**HISTORIC PRESERVATION REVIEW BOARD
STAFF REPORT AND RECOMMENDATION**

Landmark/District: **Mount Pleasant Historic District** (x) Agenda
Address: **1716 Hobart Street NW**

Meeting Date: **December 17, 2015** (x) Addition
Case Number: **16-046** (x) Alteration

The applicant, Joshua Gobel (Four Brothers LLC), designer and agent for property owner Kerry Reichs, requests concept review for reconstructing the rear enclosed porch and adding a master bedroom suite in a partial story atop this two-story rowhouse.

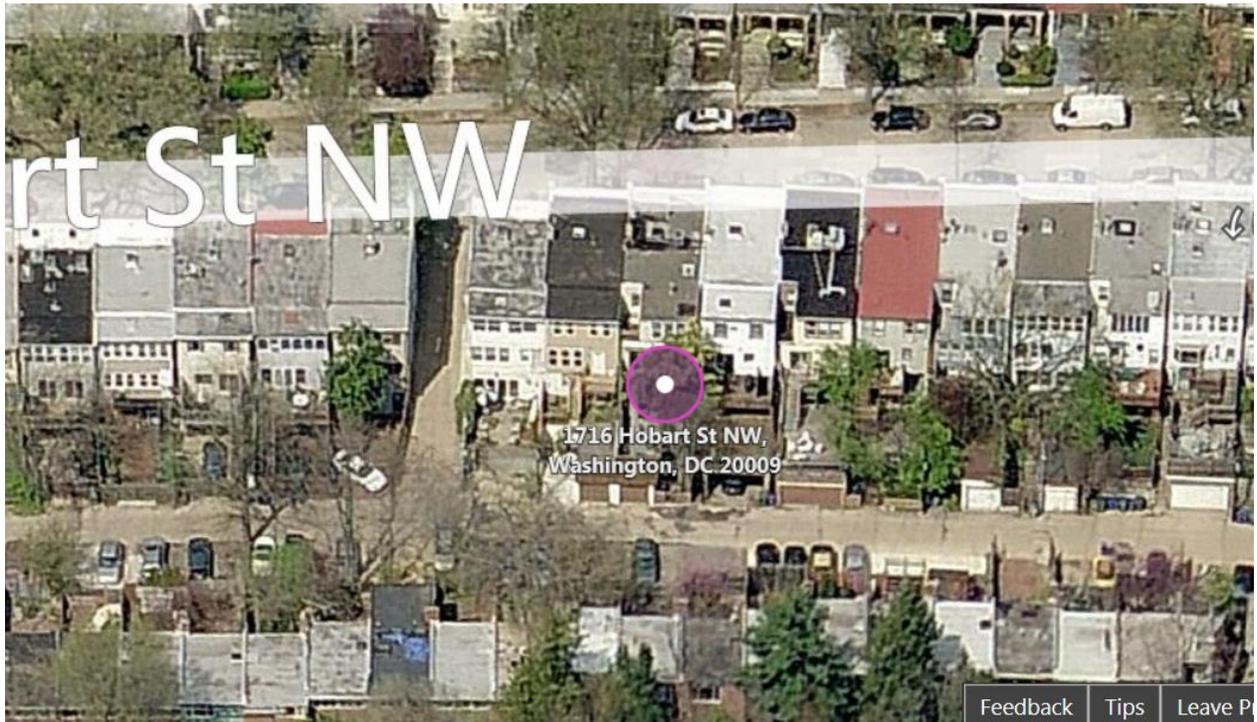
The drawings are not very clear about the relationship of the rear of this building to the backs of the abutting rowhouses, but the proposal would essentially reconstruct upon the footprint of the present two-story enclosed porches. It would also fill in a recess at the second story, as other houses on the row have been altered, but it would cantilever further rearward a second-story office bump-out and second- and third-story decks.

The addition's materials are not specified. The deck railings appear to be metal, but like the unidentified siding, they are merely specified as "painted." These should be clarified and discussed at the hearing.

It has not been demonstrated that this addition would not be visible from the street. The sightline drawing would seem to indicate so, and it appears to be fairly accurate as to the topography, but we can never be absolutely certain that an addition will be constructed as drawn. Further, the drawing does not account for typical features such as higher parapets above the party walls, which are constructed for fire separation (but may be avoided by the use of fire-rated wall and roof materials) or heightened chimneys or vents. The sightline is also taken from a point directly across the street and does not account for oblique views. The street drops toward Rock Creek, and the rowhouses step down in that direction; 1718 Hobart is a little bit lower, which raises the possibility that it would result in a glimpse of this project.¹

In addition to being invisible from the street, it is crucial that the roof addition also be set *forward* of the main rear wall plane, and those of the houses adjacent, in order to retain the roofline along the back of the row and make the roof addition recede. The drawings indicate this principle, proposing that it be set four feet forward.

Because the slope of the roof addition's roof is calculated to avoid visibility from the front, it rises toward the rear. In addition to making roof drainage difficult, it makes the rear wall taller than the first and second stories. It is recommended that the height of the roof addition come down about a foot to address the visibility issues from front and back. This would still give the new bedroom a higher ceiling than the house's present ones.

- 1. any permit be conditioned upon the roof addition and appurtenances such as mechanical equipment, chimneys, flues and vents being invisible from the Hobart Street right of way, with the drawings to indicate the same;*
- 2. the roof addition be reduced about a foot in height;*
- 3. the permit drawings portray the relationship between the proposed additions and the houses abutting, including showing the rear wall of the roof addition at least four feet forward of the rear walls of 1714 and 1718 Hobart;*
- 4. a stick test be conducted prior to permit application;*
- 5. if the stick test indicates that the addition would be visible from Hobart Street, the applicant must revise the project, or abandon the roof addition, or return to the Board; and*
- 6. the drawings specify compatible materials for siding and rails.*
